Access Compliance Report

Public Rights-of-Way

(Curb Ramps)

Intersection ID: 50321	Main Street: BELMAR_PLACE_RD	Cross Street: CINDY_LN	Location: SE
ADA ID: CEC3E2C90118	Ramp Type: Directional1	Initial Pass/Fail: Pass	Overall Compliance: No
			Severity Score: 2.5

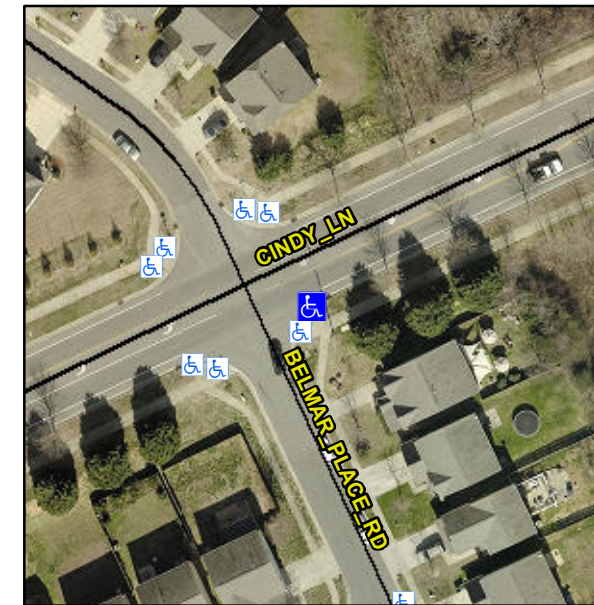
R304.5.3, R305.1.4, R305.2

Compliance	Description	Data	Compliance	Description	Data
N/A	Ramp Length (in)	87.5	Yes	Grade Break?	Yes
Yes	Ramp Width (in)	65.0	No	Grade Break Slope (%)	5.9
Yes	Ramp Slope (%)	7.5	No	Grade Break XSlope (%)	2.6
Yes	Ramp XSlope (%)	1.0			
Yes	Flare Type LT	N/A	Yes	Flare Type RT	N/A
N/A	Flare Slope LT (%)	N/A	N/A	Flare Slope RT (%)	N/A
N/A	Flare Traversable LT?	No	N/A	Flare Traversable RT?	No
Yes	Landing Length (in)	71.5	Yes	DWS Provided?	Yes
Yes	Landing Width (in)	79.0	Yes	DWS Contrast?	Yes
Yes	Landing Slope (%)	0.2	Yes	DWS Length (in)	24.0
Yes	Landing X Slope (%)	1.7	No	DWS Full Width?	No
N/A	Landing Curb? (Y/N)	N/A	Yes	DWS Offset LT (in)	13.0
N/A	Shared Landing?	Yes	No	DWS Offset RT (in)	4.0
Yes	Gutter Ponding?	No	Yes	Gutter Slope (%)	4.1
Yes	Gutter Lip Ht (in)	0.0	No	Gutter X Slope (%)	3.2
N/A	Painted X Walk1?	No		Road Slope (%)	1.5
	X Walk 1 Direction	To N		Road X Slope (%)	1.2
	X Walk 1 Width (in)	N/A		Clear Space?	Yes

**Remove & Replace Entire Ramp.
Remove & Replace Gutter.**
